Recall Campaign

January 2010
FL569AB
NHTSA #09V-461
REVISED NOTICE

Subject: KPPS Adjustable Brake Pedals

Models Affected: Specific Freightliner Custom Chassis B2 school bus chassis (Thomas Built Buses Saf-T-Liner C2 school buses) manufactured October 6, 2004, through November 12, 2009, and XC motorhome chassis manufactured March 6, 2007, through December 11, 2009, with certain Kongsberg Power Products Systems (KPPS) adjustable brake pedals. (Please note, there are also three XB shuttle bus chassis included in this recall.)

Fig. 1, Adjustable Brake Pedal Assembly

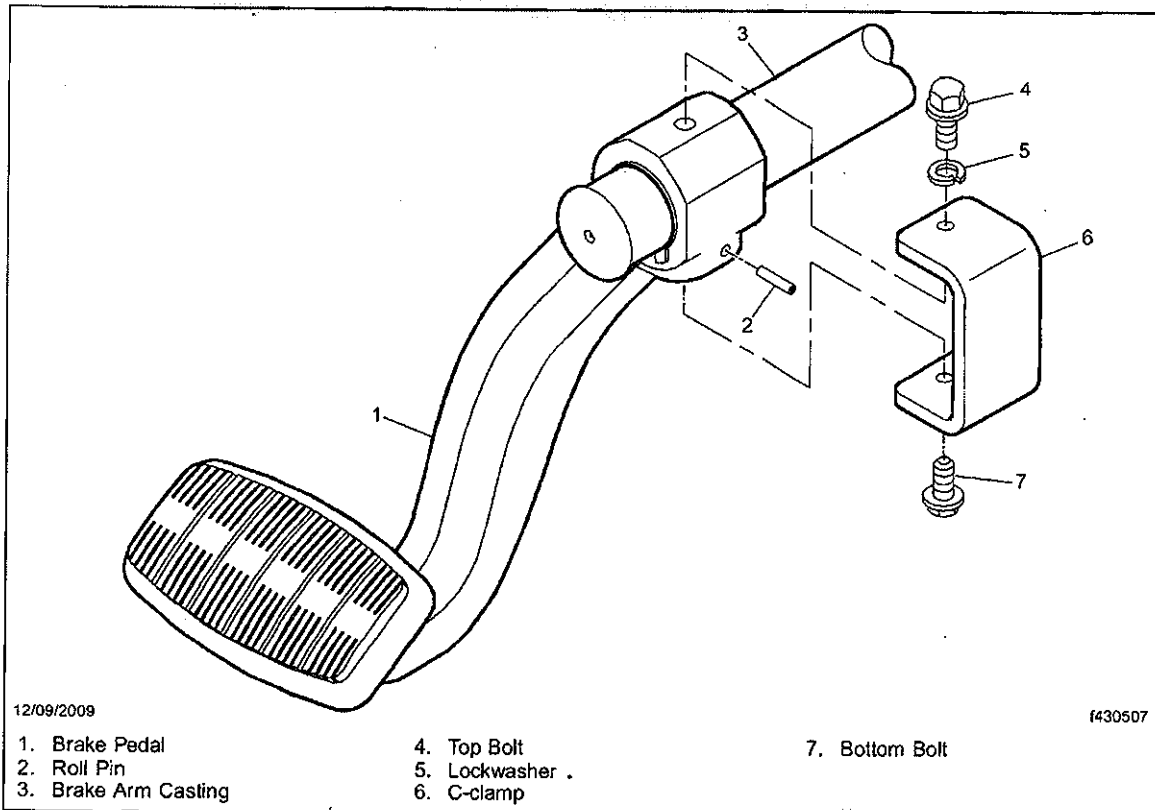
1. With the C-clamp in your hand, install the C-clamp assembly in the guide hole at the top of the brake arm casting. Make certain the C-clamp is against the casting. The bolt with the lockwasher should be installed at the top, as shown in Fig. 1, Items 4 and 5. Then tighten the bottom bolt 40 ± 5 lbf-in (452 ± 5 N-cm).
2. Clean a spot on the base label (Form WAR259), write the recall number, FL569, on a blank completion sticker (Form WAR260), and attach it to the base label.
3. Remove the chocks from the tires.
